UNITED STATES PATENT AND TRADEMARK OFFICE

APPLICATION NO.	FILING DATE	FIRST NAMED INVENTOR	ATTORNEY DOCKET NO.	CONFIRMATION NO.
10/714,366	11/13/2003	Christoph A. Wasshuber	TI-36280 (032350.B536)	1864

Office Action Summary	Application No. 10/714,366	Applicant(s) WASSHUBER, CHRISTOPH A.	
	Examiner Thinh T. Nguyen	Art Unit 2818

DETAILED OFFICE ACTION

FIG. 11

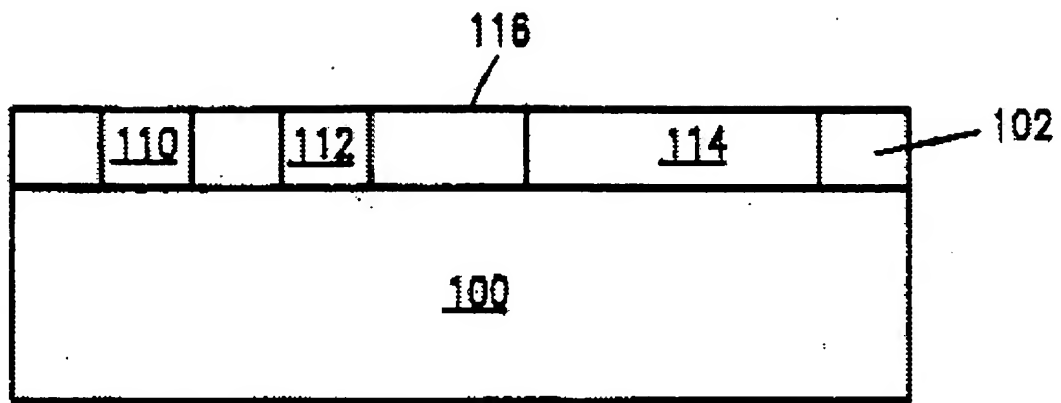
Chang (the abstract, fig 11) disclose a semiconductor structure used in manufacturing a semiconductor device, comprising: a substrate layer (fig 11 layer 100) first and second isolation regions formed by etching (column 2 line 15-16) an oxide layer provided on the substrate layer to define an epitaxial growth surface of the substrate layer for epitaxial growth of a substrate material on the epitaxial growth surface between the first and second isolation regions; and an active region (fig 11 layer 114) comprising the epitaxially-grown substrate material between the first and second isolation regions, the active region formed by epitaxially growing the substrate material on the epitaxial growth surface of the substrate layer.

FIG. 3

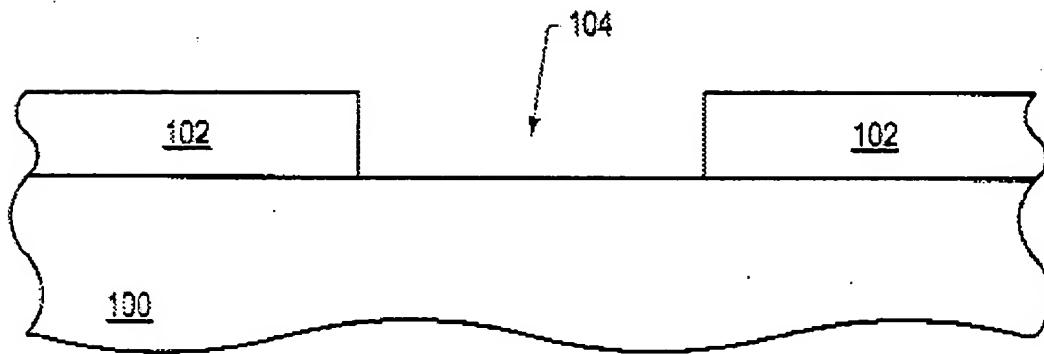
Similarly, Gardner et al.(the title, the abstract, fig 3,fig 4) and Hsu (the abstract, fig 7,) disclose the same invention

Fig. 7

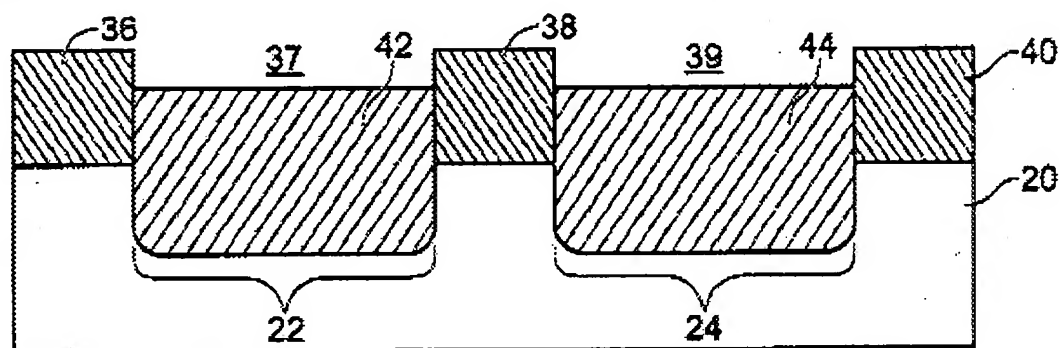
Hsu discloses (fig 7, fig 9) a second active regions, meanwhile since both Chang (the abstract) and Gardner (in the Background of the invention) disclose one common structures of a plurality of active VLSI transistors built on the same substrate.; these structures will inherently have a second active regions and a third isolation regions

FIG. 14

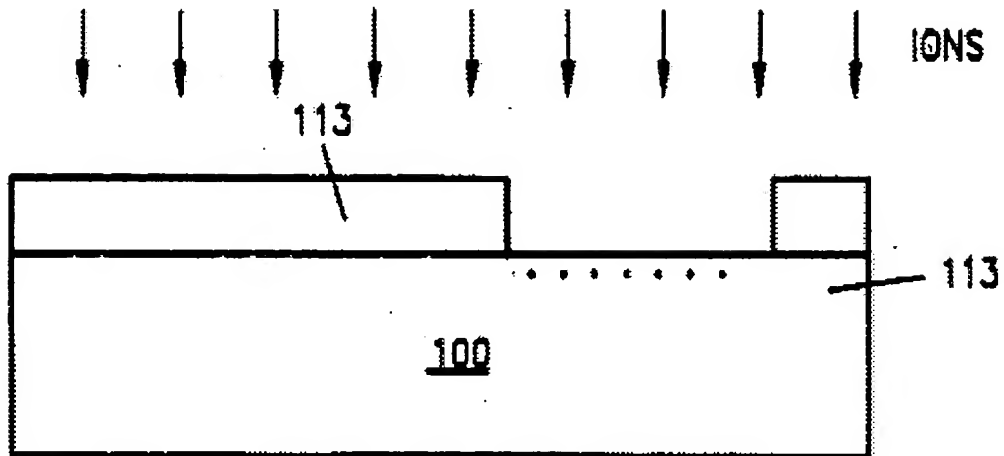
Chang et al. (the abstract, fig 14,fig 15,column 3 lines 9-13) disclose a semiconductor structure use in manufacturing wherein the epitaxially-grown substrate material comprises dopant material introduced into the epitaxially-grown substrate material as the epitaxially-grown substrate material is grown on the epitaxial growth surface of the substrate layer.

FIG. 7

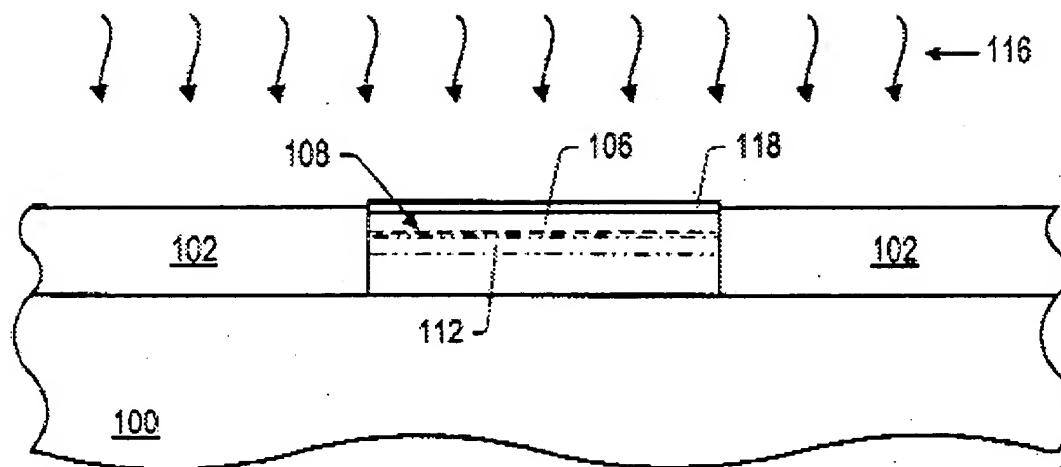
Similarly, Gardner et al. (the abstract, fig 7) and Hsu (the abstract, fig 9) disclose the same invention.

Fig. 9

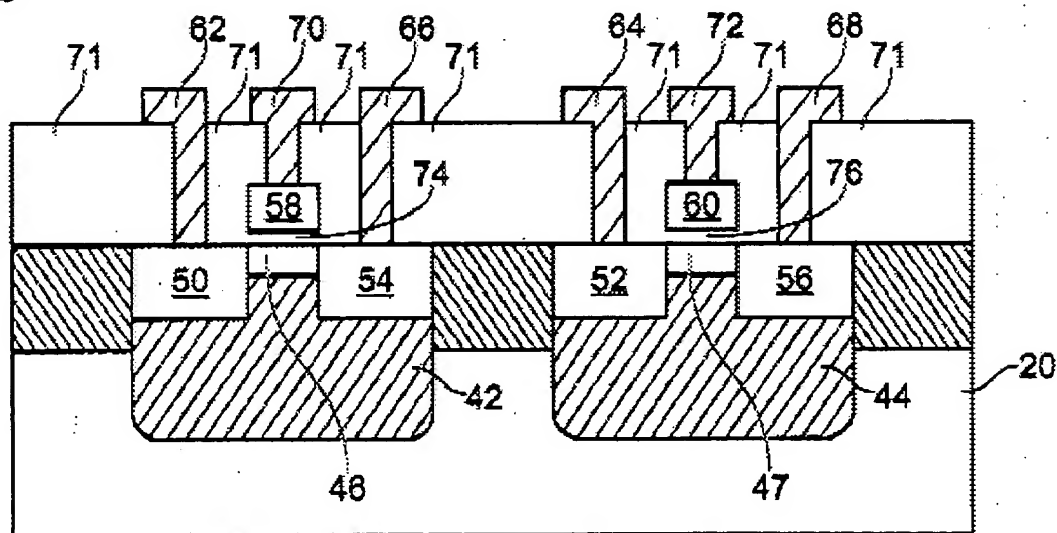
Hsu (fig 9, column 5, line 65-66) disclose a semiconductor structure wherein the isolation regions and the active region are formed independent of any shallow trench isolation (STI) process in which an isolation region is formed by etching a trench in the substrate layer and filling the trench with an oxide material to define an adjacent active region of the structure.

Hsu (the abstract, fig 9) disclose a structure of CMOS device.

FIG. 6

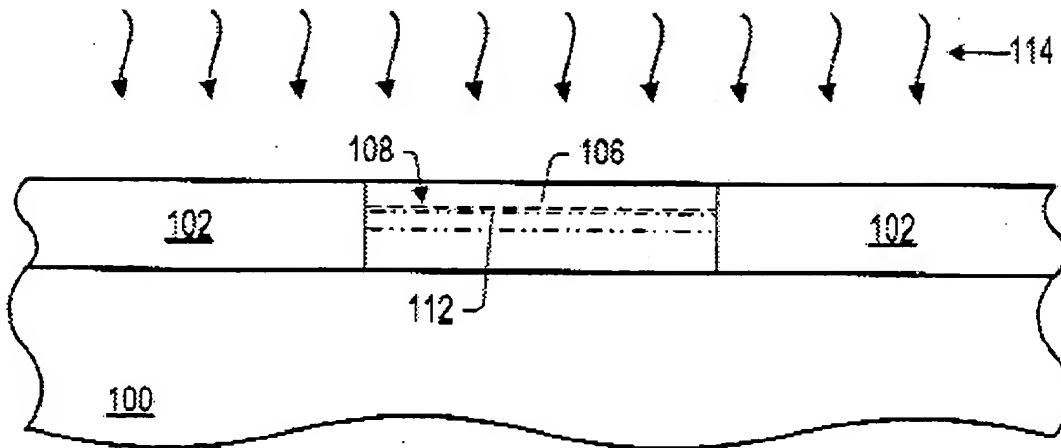
Gardner disclose a device (fig 6) that has an implanted and annealed structure

FIG. 4C

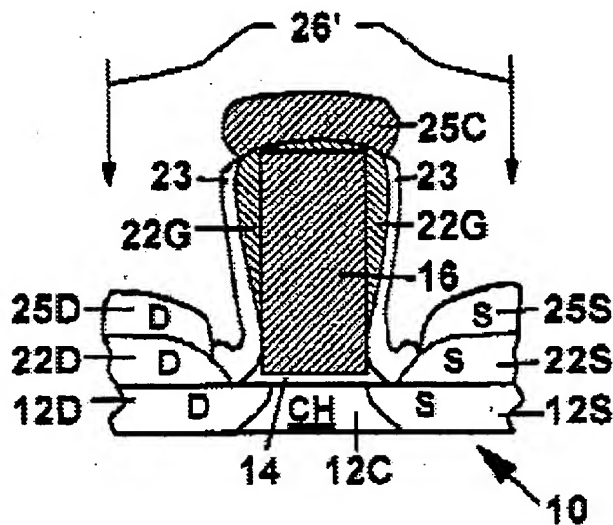
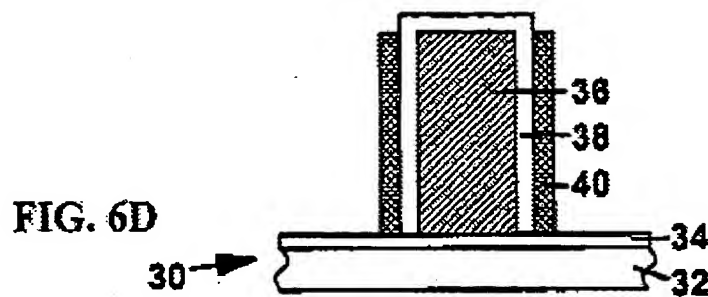
Natzle et al. (in fig 5C) teach how to fabricate a structure with raised source and drain
